Florida Department of Environmental Protection Inspection Checklist

Facility Name:HARDEE COUNTY REGIONAL LANDFILLOn-site InspectionStart Date:10/08/2021On-site InspectionEnd Date:10/08/2021WACS No.:40612Facility Street Address:685 AIRPORT ROADCity:WAUCHULACounty Name:HARDEEZip:33873

Routine Operation Inspection for Landfill - Class I Routine Operation Inspection for Other - Waste Tire Collection Center

Item A - June 2021 Survey

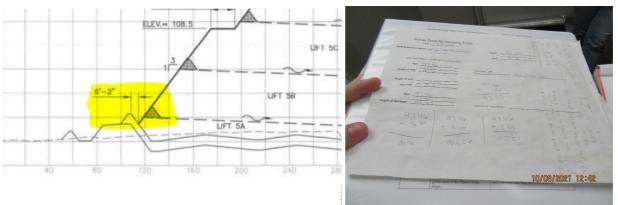
A) Per section K.2.f of the facility's Operation Plan, documentation demonstrating that monthly surveys of the landfill to confirm and monitor waste filling elevations, slopes, and dimensions must be kept on-site and available for review upon the Department's request. Department personnel observed these records for past surveys, but not for recent surveys (e.g. September and October 2021).

Corrective Action: A) Please provide the Department with the past three monthly surveys of the landfill to demonstrate compliance with the method and sequence of fill requirements outlined in the Operation Plan within 30 calendar days of the date listed on the attached Warning Letter.

Phase I - Mowing Ruts

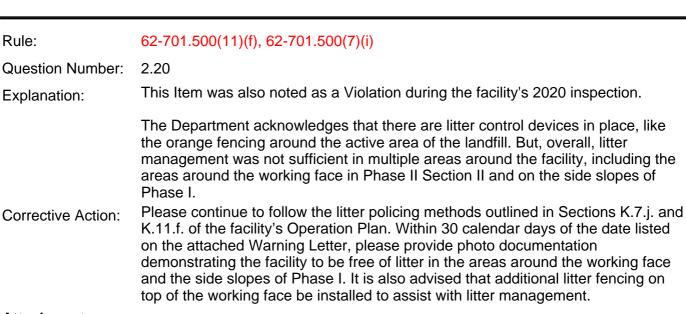
Rule:	62-701.500(7)(f)
Question Number:	2.19
Explanation:	This Item was also noted as a Violation during the facility's 2020 inspection.
Corrective Action:	The eastern and western sides of Phase I appeared to have insufficient intermediate cover in some areas due to ruts created by mowing and erosion. The grass vegetation also appeared to be lacking within these areas. Within 30 calendar days of the date listed on the Warning Letter, please provide the Department with photo documentation showing that all ruts, eroded areas, depressions, and subsidence filled and seeded. Please also provide photo documentation showing all areas lacking grass vegetation are seeded.
Attachments:
